NORTH CAROLINA  
DEPARTMENT OF INSURANCE

**2002 NORTH CAROLINA ACCESSIBILITY CODE  
WITH  
2004 AMENDMENTS  
FOR US DOJ CERTIFICATION**

The attached package contains the 2004 Amendments to the 2002 North Carolina Accessibility Code. These amendments were:

**Adopted by the NC Building Council on June 8, 2004  
Approved by the Rules Review Commission on July 22, 2004  
and become  
Effective on August 1, 2004  
Mandatory Enforcement Date is January 1, 2006**

11.4- ACCESSIBLE TOILET STALLS

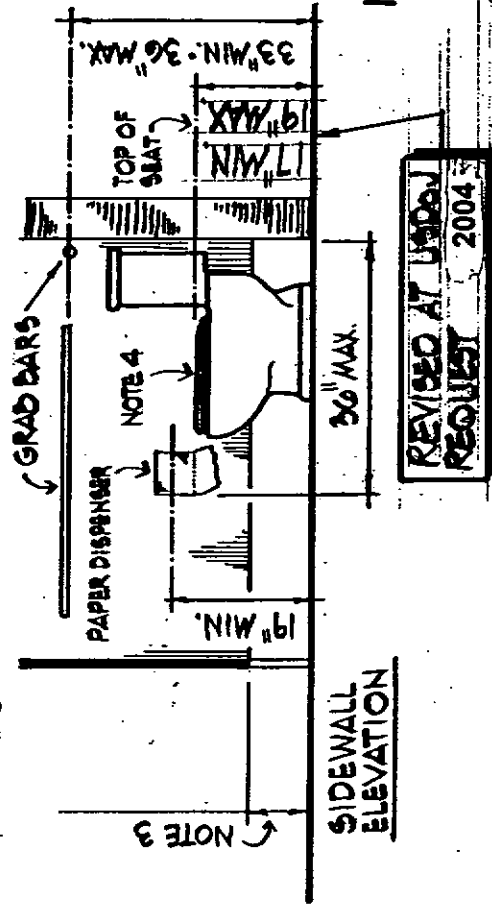
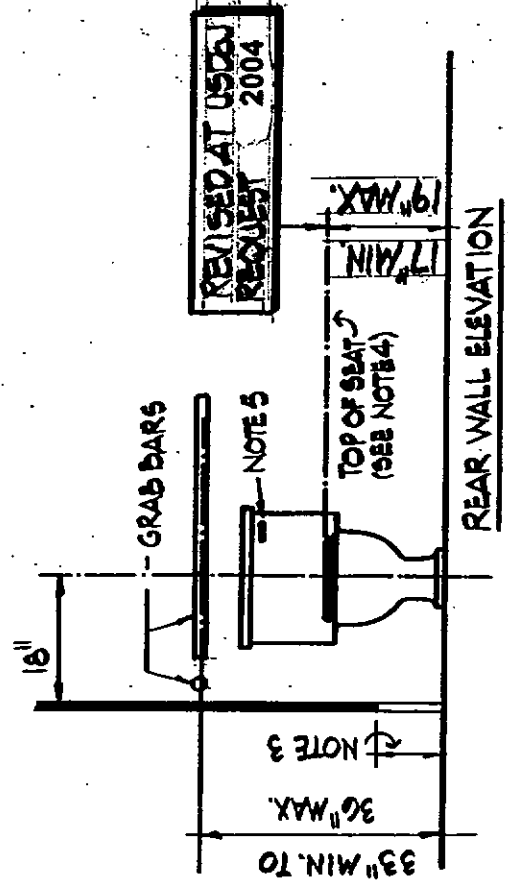
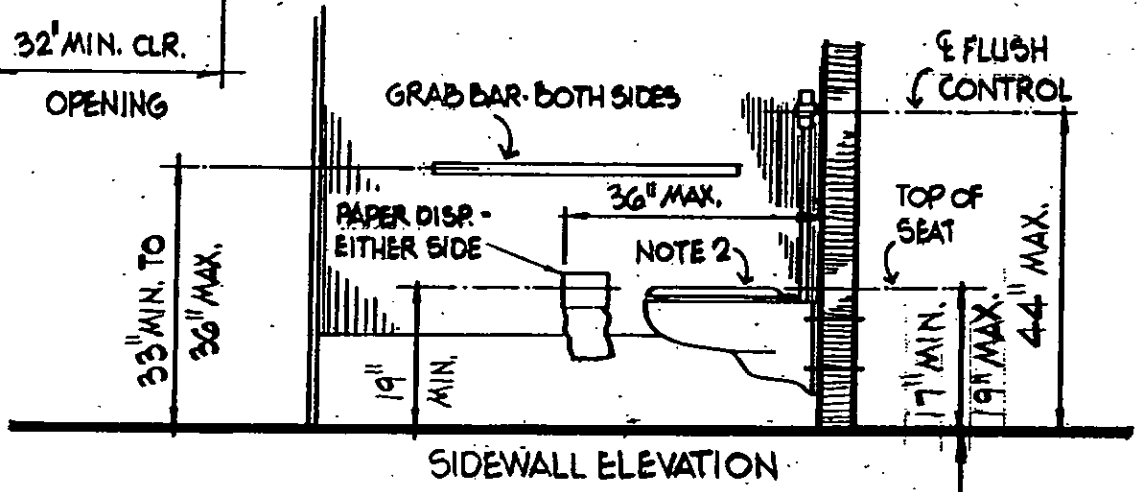
REVISED AT USDOJ REQUEST 2004

REVISED AT USDOJ REQUEST 2004

REVISED AT USD<sub>o</sub>J  
REQUEST 2004

11.6.2-LAVATORY

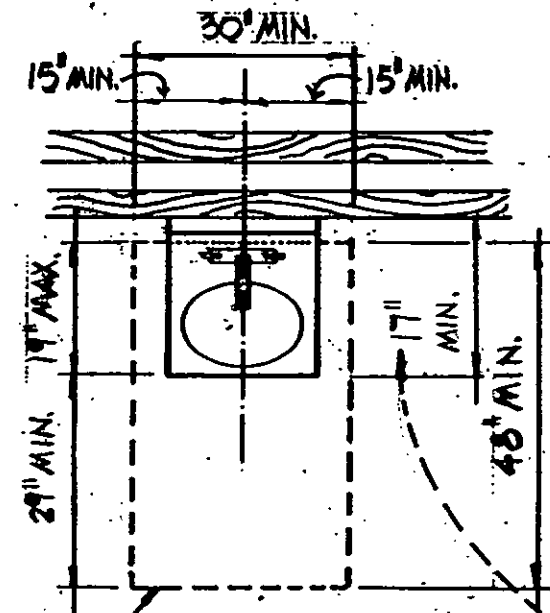
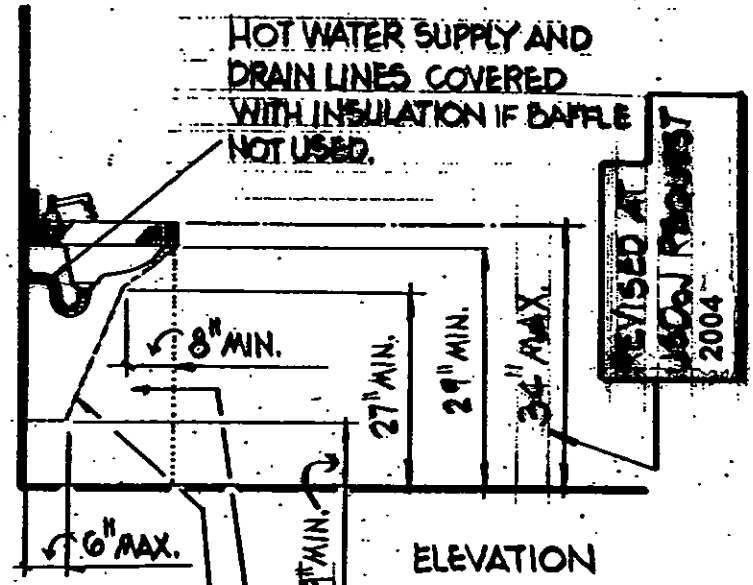
REVISED AT USD<sub>o</sub>J  
REQUEST 2004

REVISED 2004

**Revised At**  
**USDoJ**  
**Request**
- (2) The lavatory shall extend 17 inches (430 mm) minimum measured from the wall or partition to the most forward edge of the fixture. **ADAAG Fig. 31**

11.7.1- MIRRORS

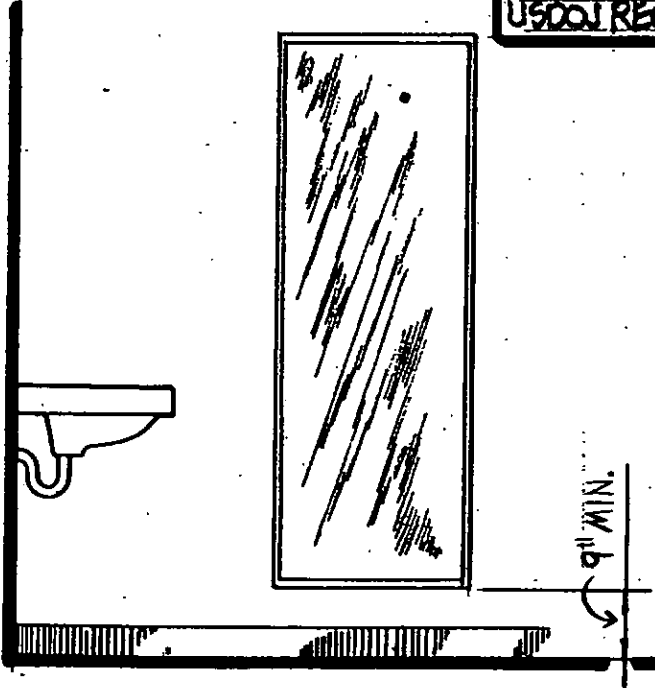
REVISED AT  
USDOJ REQUEST 2004

\* 11.7.1 If mirrors are provided at lavatories, then the mirror over the accessible lavatory shall be ***placed with its bottom edge at 40 inches (1015 mm) maximum*** above the finished floor. ***A full length mirror may be used in place of one located over the lavatory provided that it is located within the toilet room on an accessible route and the mirror bottom edge is at 9 inches (230 mm) minimum above the finished floor.***

11.7.2- SHELVES

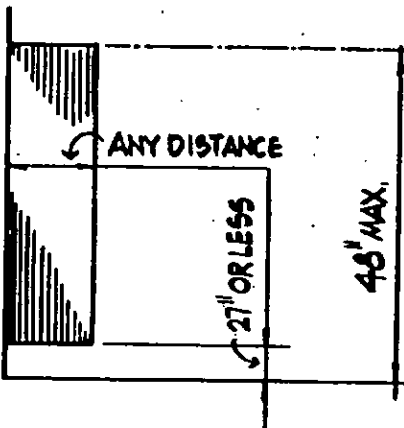
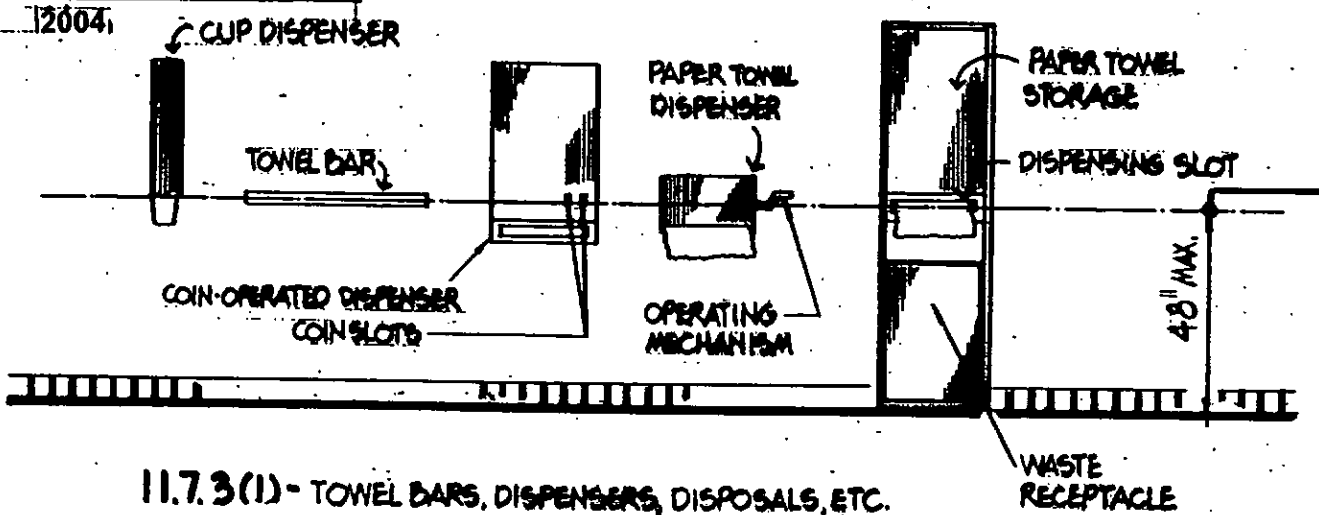
REVISED AT USDOJ REQUEST

MOUNTING HEIGHT(S) OTHER THAN 48" ARE PERMITTED PROVIDED THE INSTALLATION COMPLIES WITH THE REQUIREMENTS OF 16.2.1 (FORWARD REACH) OR 16.2.2 (PARALLEL [I.E., SIDE] REACH), AS APPLICABLE.

ADDED AT USDOJ REQUEST

**11.11.3-ACCESSIBLE SINKS**  
(SEE ALSO, 11.11.1 AND 11.11.2)

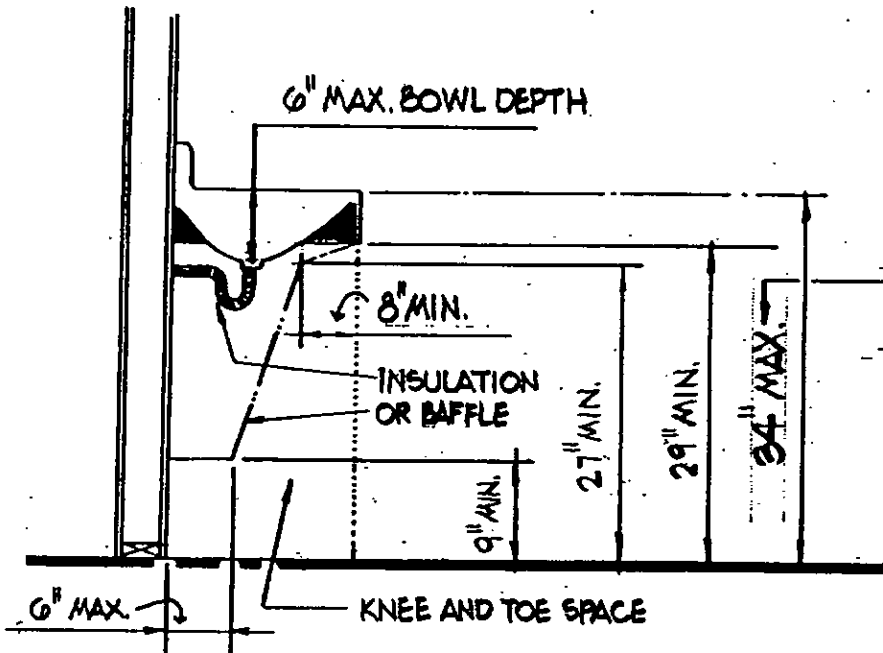
REVISED AT USER REQUEST 2004

15.11 - PLATFORM WHEELCHAIR LIFTS

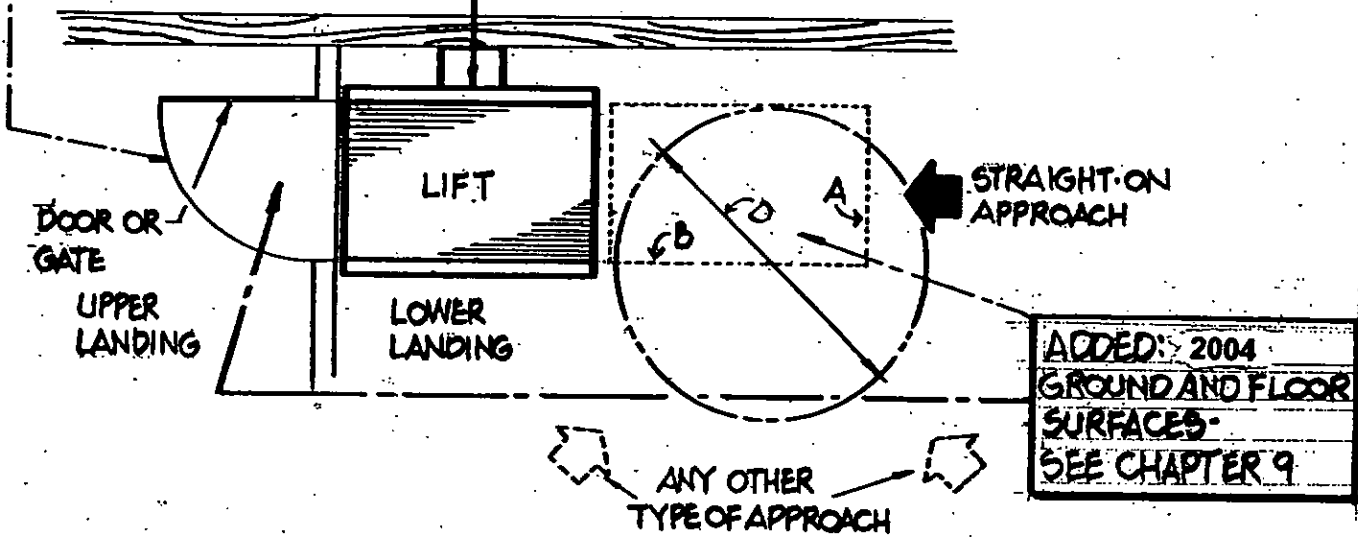
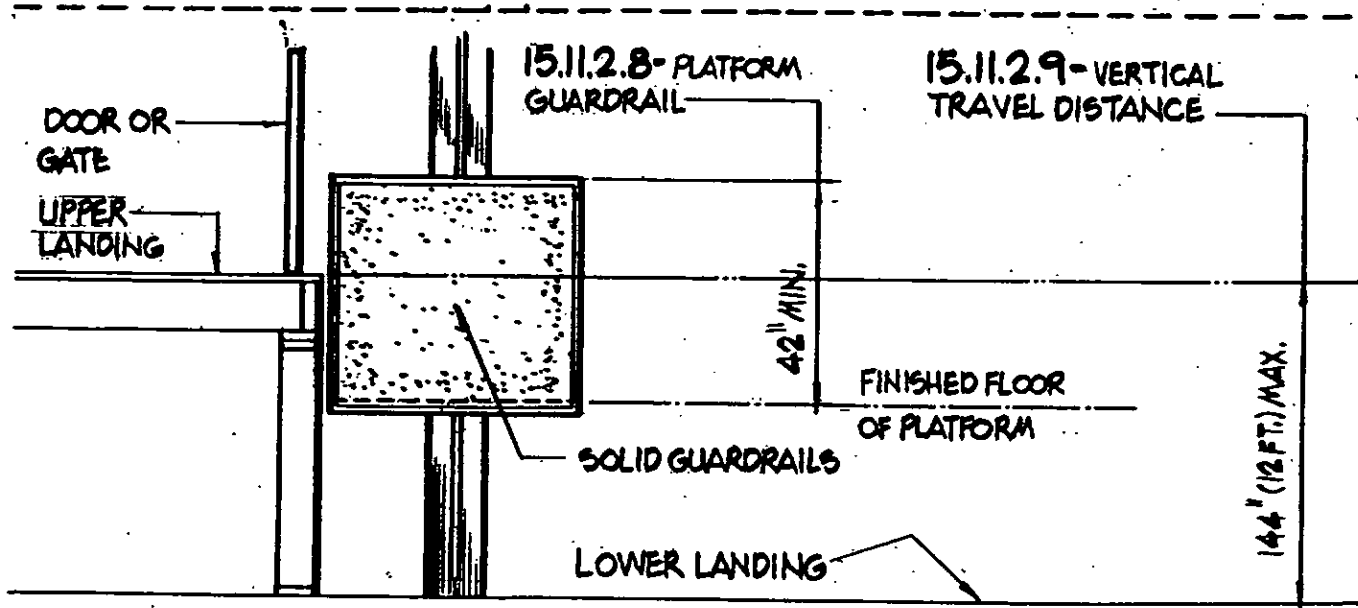
ADDED: 2004  
DOOR/GATE - SEE  
CHAPTER 7

ADDED: 2004  
CONTROLS - OPERATING MECHANISMS  
SEE CHAPTER 16
